Title: Townsite Campground Infrastructure, Waterton Lakes National Park		
Solicitation No.: / N° de l'invitation : 5P420-17-5226/A	Amendment No.: / N° de modification de l'invitation : 001	Date: July 28, 2017 Date : 28 juillet 2017
GETS Reference No.: / N° de référence de SEAG : PW-17-00786661		
Solicitation Closes: / L'invitation prend fin :		
At: 02:00 PM	On: August 8, 2017	Time Zone: Mountain Daylight Time (MDT)
À : 14h00	Le : 8 août 2017	Fuseau horaire : Heure avancée des Rocheuses (HAR)
Address Inquiries to: / Adresser toute demande de renseignements à : Nicole Levesque-Welch		
Telephone No.: / N° de téléphone : (403) 292-4691	Fax No.: / N° de télécopieur : (403) 292-4475	Email Address: / Courriel : nicole.levesque-welch@pc.gc.ca
TO BE COMPLETED BY THE BIDDER (type or print) À ÊTRE COMPLÉTER PAR LE SOUMISSIONNAIRE (taper ou écrire en caractères d'imprimerie)		
Vendor/Firm Name – Nom du fournisseur/de l'entrepreneur

AMENDMENT 001

This amendment is being raised to respond to questions submitted in writing and post the questions and answers submitted during the mandatory site visit for solicitation 5P420-17-5226/A:

LIGHT BASE STANDARD

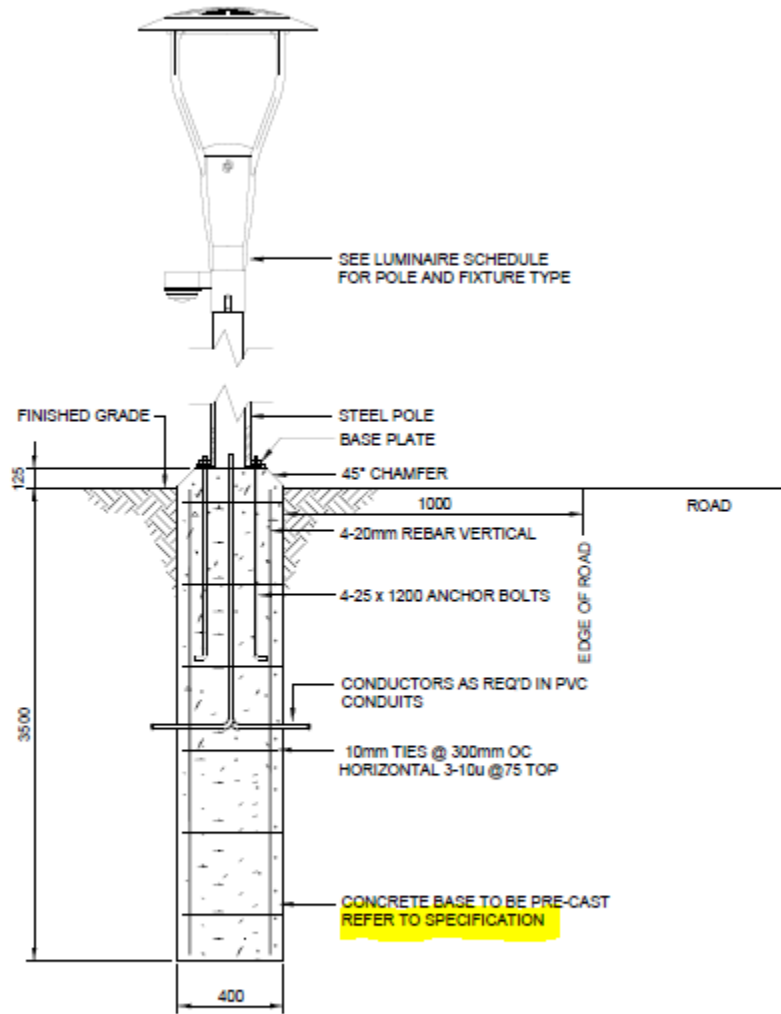
Q22: Could you provide the specification on the light base as per Plan E-1006, Detail 8 – concrete precast base?

A22: Plan E-1006, Detail 8 – concrete precast base: “refer to specification” shall be replaced with “as per manufacturer’s specifications. Shop drawings to be submitted to Departmental Representative for approval prior to ordering”.
